## **Comments on NTIA BPL Report 04-413**

(By, James K. Boomer, May 17, 2004)

Figure 1-Binary Phase Shift Keying (BPSK) Bit Error Rate vs. C/N Ratio

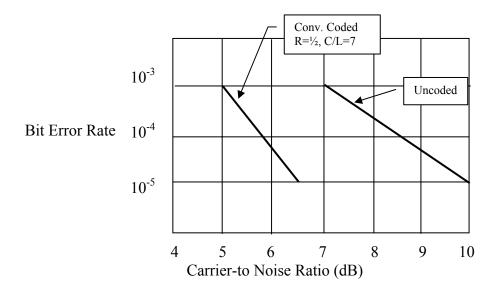
For EMC, BPL interference must not raise the licensed station's receiver noise floor more than 1 dB. This requirement stems from the fact that a 1 dB decrease in carrier-to-noise ratio will increase a modern, coded (e.g. convolutional rate one-half code with maximum likelihood soft decision detection) binary phase shift keying (BPSK) data system's bit error rate (BER) more than an order of magnitude, as shown in Figure 1.

Figure-2 Azimuth Plot, Three 340-meter Long Power Lines (See Text)

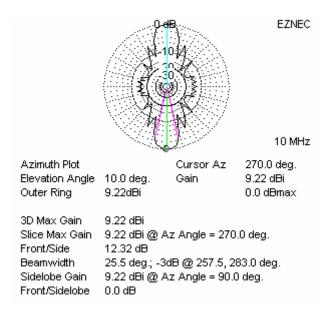
Antenna modeling reveals that power lines can have substantial directivity gains. One example is shown in Figure 2, which is an azimuth plot of three 10 mm diameter power lines, 340 meters long, spaced 60 cm. apart, and 8.5 meters above the ground. Each line is terminated in 50Ohms at each end, and one outside line is fed at the center. Note that this system has a directivity gain of 9.22dBi at an elevation angle of ten degrees, at right angles to the wire run. So, if the wires are running north and south, the maximum gain will be east and west. Accordingly, the BPL system's transmit power will be magnified by this amount. Additionally, any power received from licensed station transmitters will also be magnified by this amount.

It can be shown that some power line runs like the one above have some 15 dBi directivity gain at some frequencies. Additionally, licensed stations have antennas with directivity gains of 15 dB or more. Thus, the allowable field strength at the licensed station should be 30 dB less than the figures in the seventh column of Table 2 in order for us to have a reasonable assurance of EMC. Accordingly, the recommended maximum allowable field strength numbers are shown in the eighth column of Table 2.

Figure 3- Field Strength vs. Distance 1 KW radiated, Horizontal Polarization, Dipole Antenna, 10 Ft. above Good Soil (Data from Bell Laboratories)

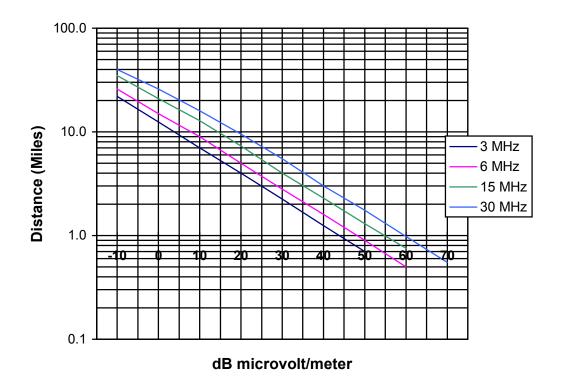
Figure 3 is a set of field strength curves, the data for which are taken from a classic set of ground wave propagation data prepared by Bell Laboratories for the Government in 1946.

Note that the Figure 3 data are based on a 1,000-Watt transmitter with a half-wave dipole ten feet above the ground. To get accurate data for a particular scenario, we utilize correction factors provided by Bell Laboratories.

From Figure 3, at a distance of 0.7 mile, the field strength is 60 dB microvolt/meter. The correction factors to arrive at the actual field strength at 0.7 mile are:
